From: Tammara, Seshagiri
Sent: Wednesday, September 17, 2014 2:36 PM
To: Pickett, Douglas
Subject: FW: IPEC Gas Line 50.59 Review

Additional Modeling for proposed AIM Project Pipeline Impact on IPEC

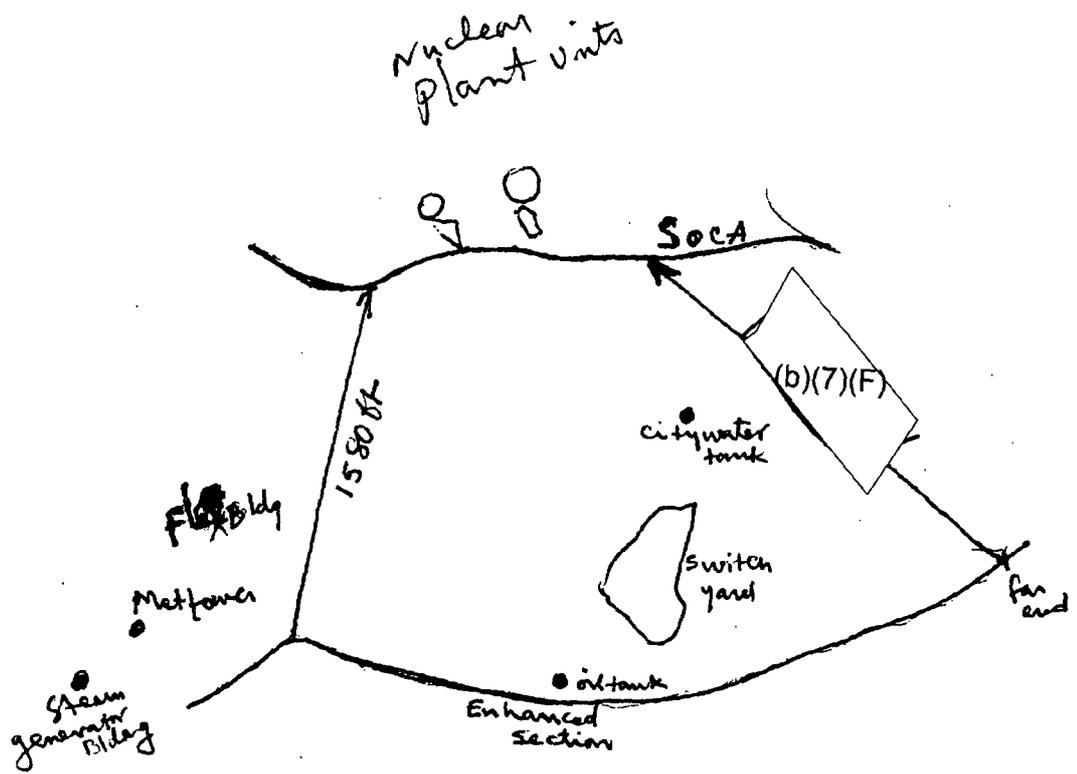
(b)(5),(b)(7)(F)
